Re: Land East of A10 Buntingford, Hertfordshire (Ref: 3/23/1447/OUT)

Outline planning for the development for up to 350 dwellings, with up to 4,400 sqm of commercial and services floorspace (Use Class E and B8) and up to 500 sqm of retail floorspace (Use Classes E) and other associated works including drainage, access into the site from the A10 and Luyne Rise (but not access within the site), allotments, public open space, and landscaping.

DATE:	15 September 2023	CONFIDENTIALITY:	Confidential
SUBJECT:	Response to Active Travel England Comments		
PROJECT:	70094210 - Land at Buntingford West	AUTHOR:	Gideon G
CHECKED:	Mehmet A	APPROVED:	Mehmet A

ROUTE AUDIT

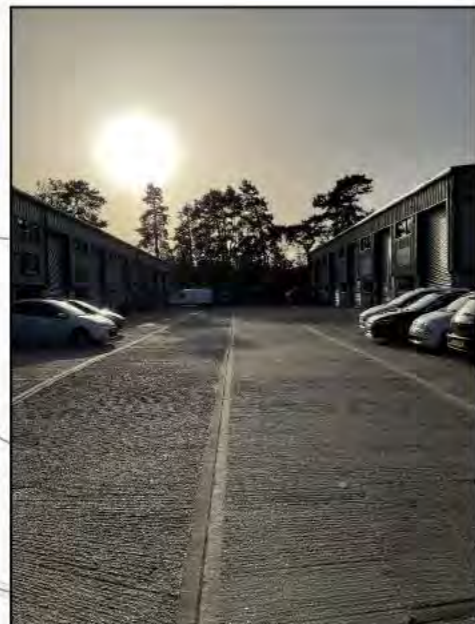
While the maps provide information on the distances to key facilities they do not provide information on the quality of the routes and therefore whether they are of the required standard to incentivise walking, wheeling and cycling trips. Key to this site include the routes to the facilities on High Street/Station Road, routes to education facilities (primary school, middle school and college) and places of work, and to the village of Aspenden.

Routes to key facilities must be carefully considered to ensure that they are designed in accordance with the standards in LTN 1/20 and can accommodate future walking, wheeling and cycling trips. A more detailed analysis of them is required in order to provide an understanding of the design and deliverability of schemes which are required to embed active travel and ensure that the modal share targets are met. The Level of Service Tool and Junction Assessment Tool in LTN 1/20, and the Walking Route Audit Tool, should be used to assess key routes and develop appropriate schemes compliant with current standards.

However, at this stage of the proposals the routes to key destinations within the area have been assessed using the LTN 120 Level of Service Tool, Junction Assessment Tool and the Walking Route Audit Tool to provide an assessment of the external infrastructure which the proposed development will be connecting to. Details of the assessment has been provided at Annex C.

PROJECT No:	DRAWING No:	REV:
7008893	7498-GA-02 REV G	G

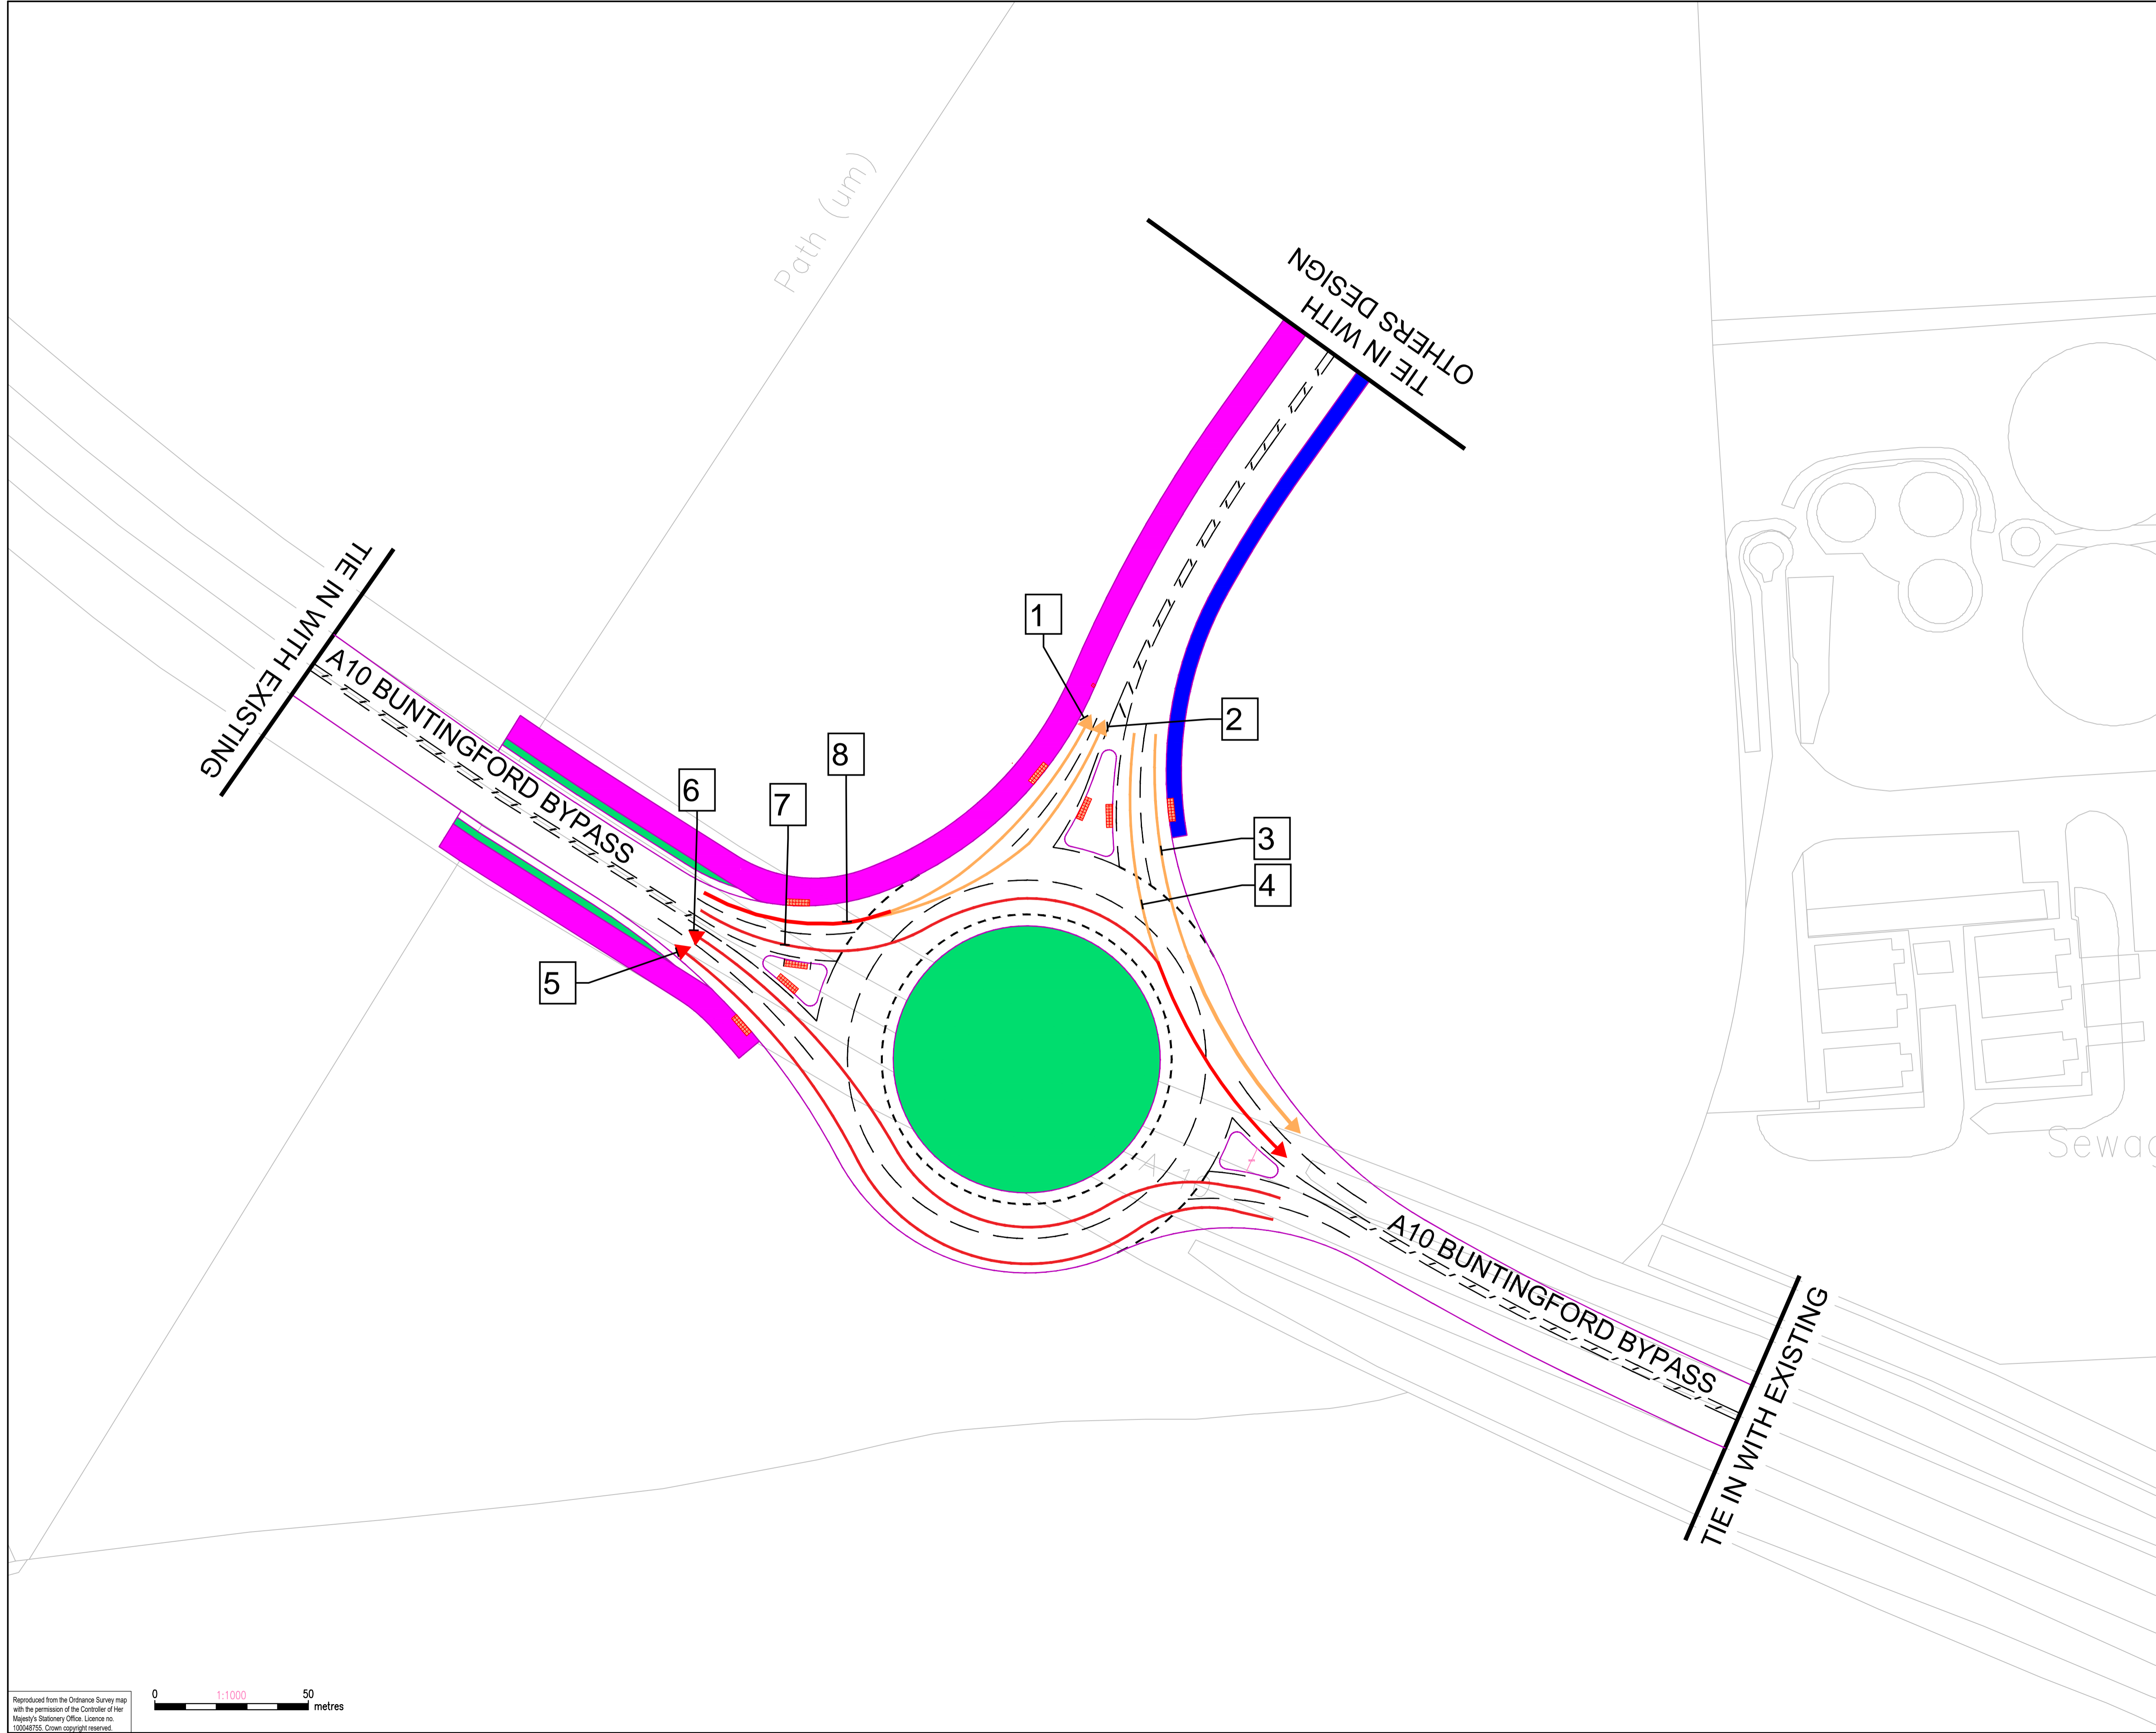
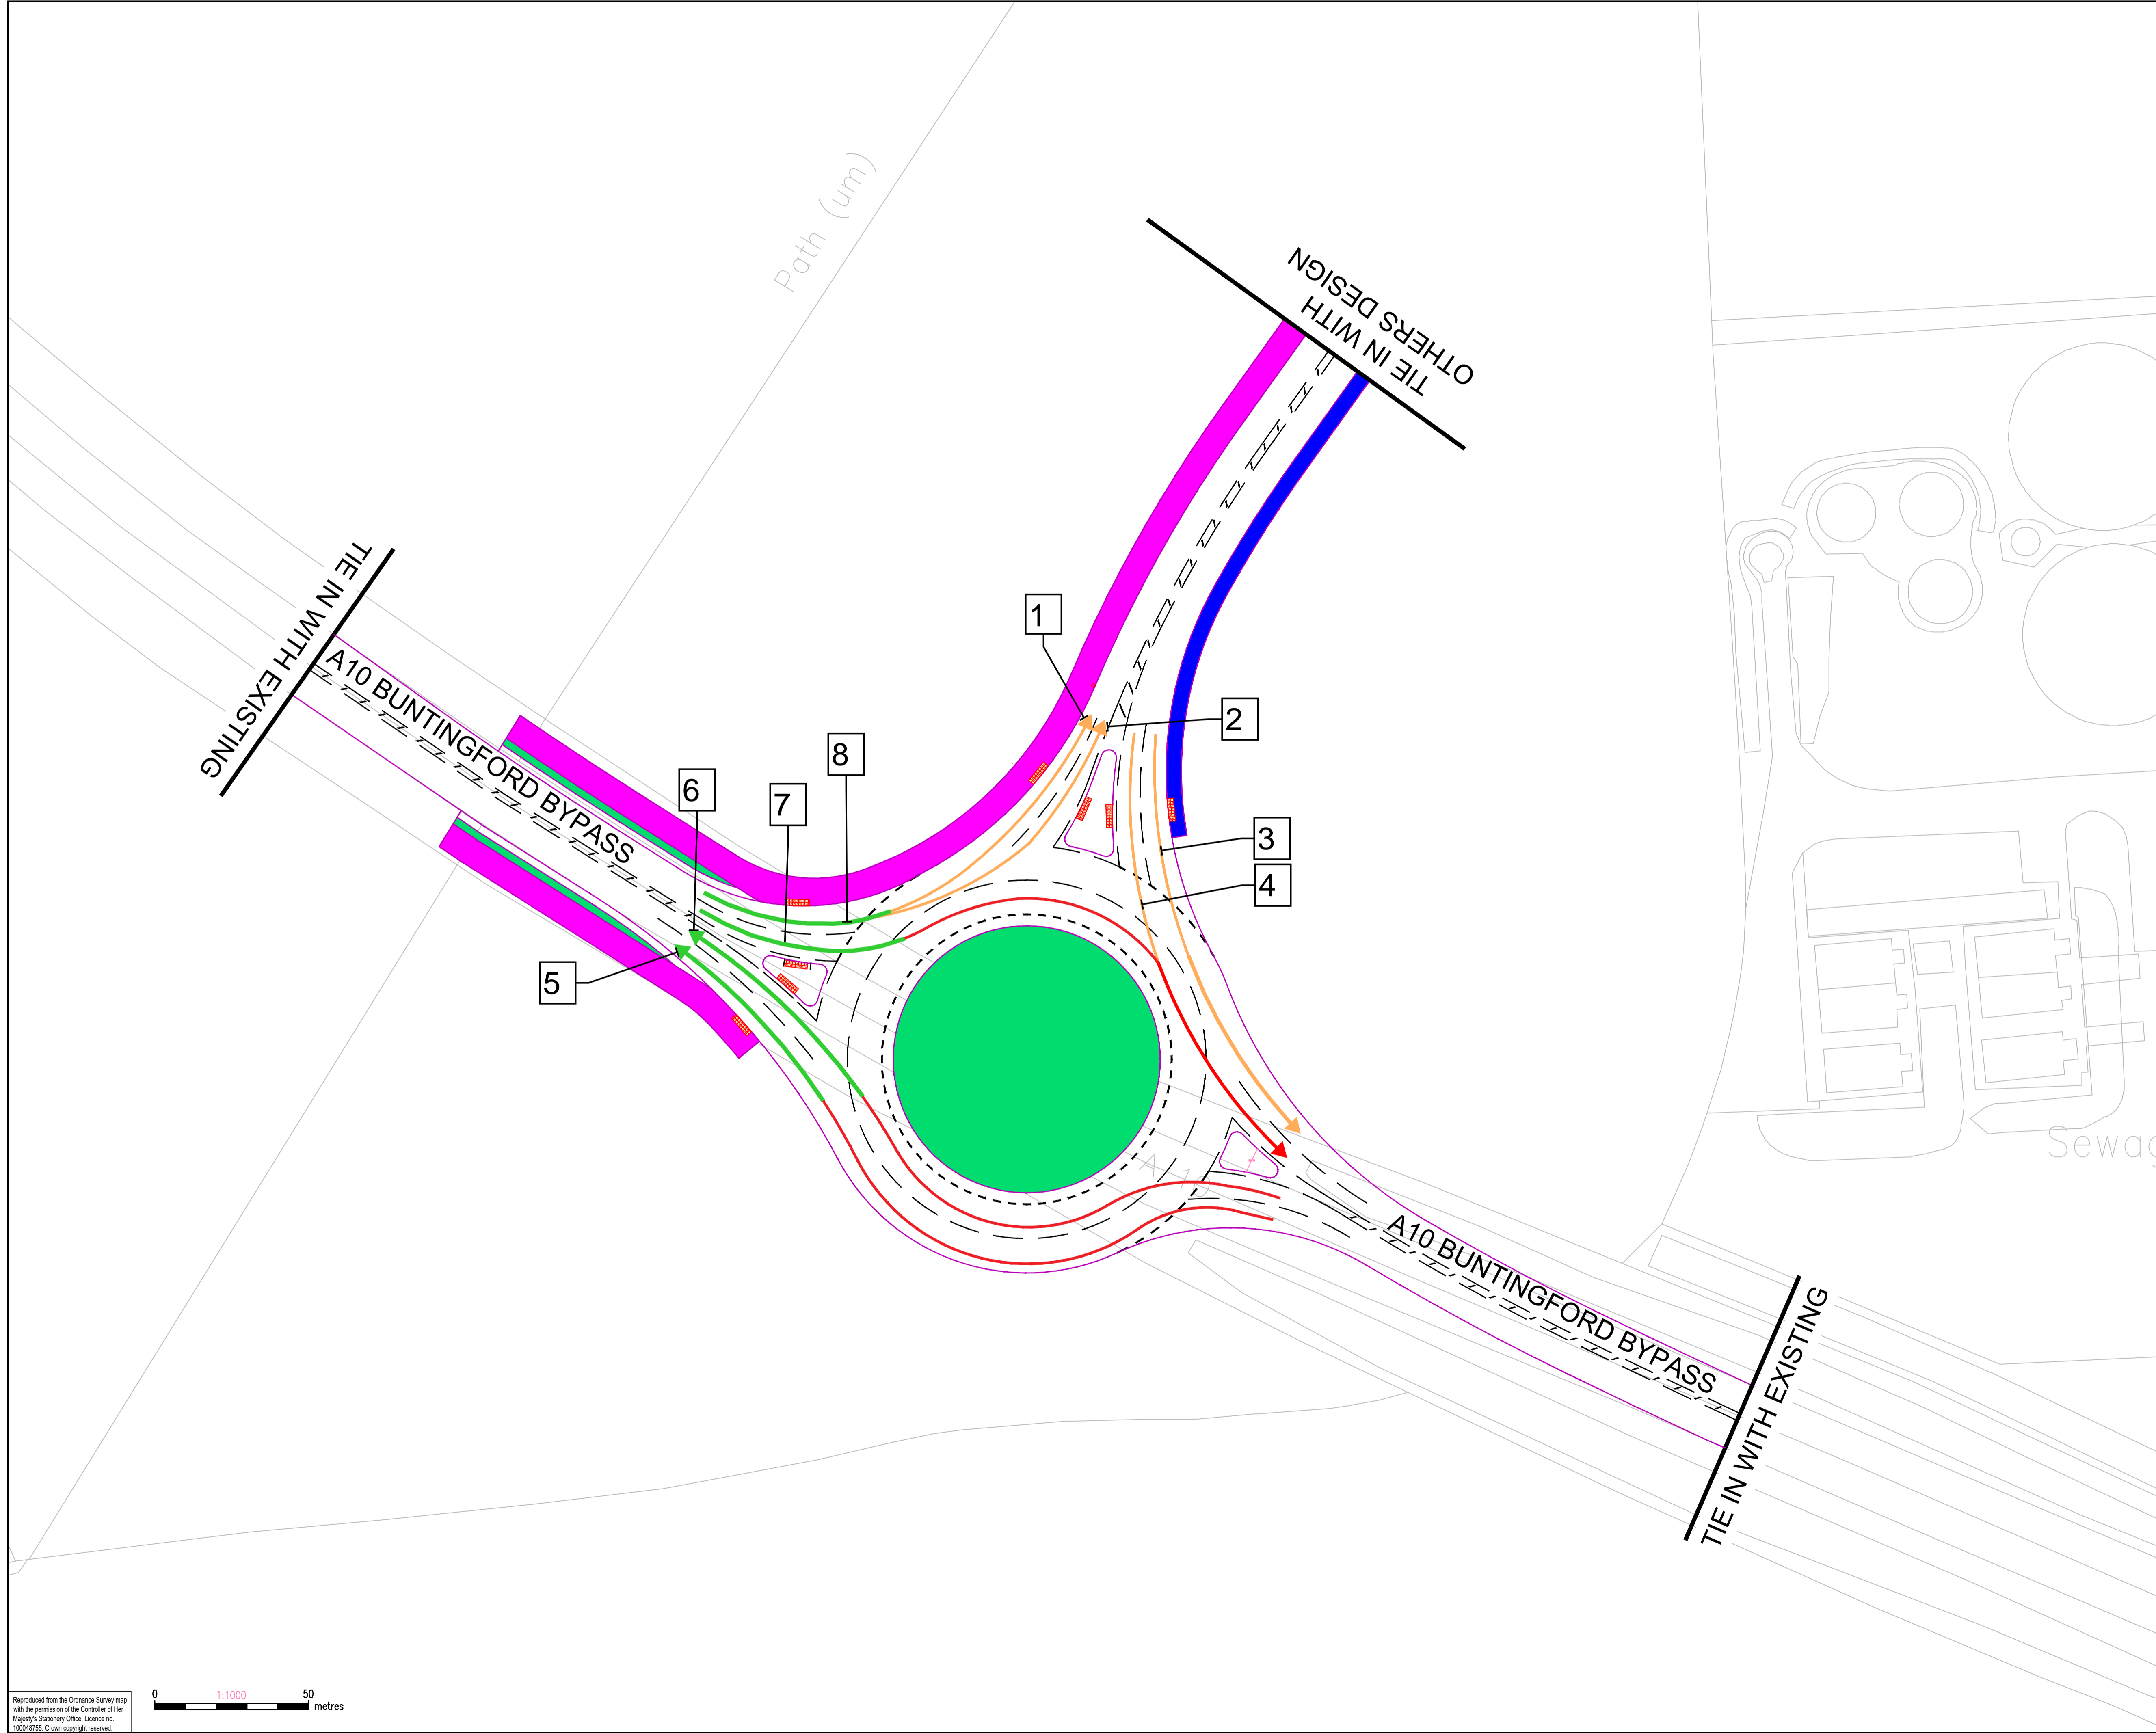
- Overall areas of Concern
- Trip Generation
- Qualitative review of external active travel routes
- Permeability and access to the site
- Comments on Development Framework Plan (DR-A-1002)
- Comments on Site Access Arrangement (7498-GA-02-REV G)
- Cycle Parking
- Bus Services
- Travel Plan
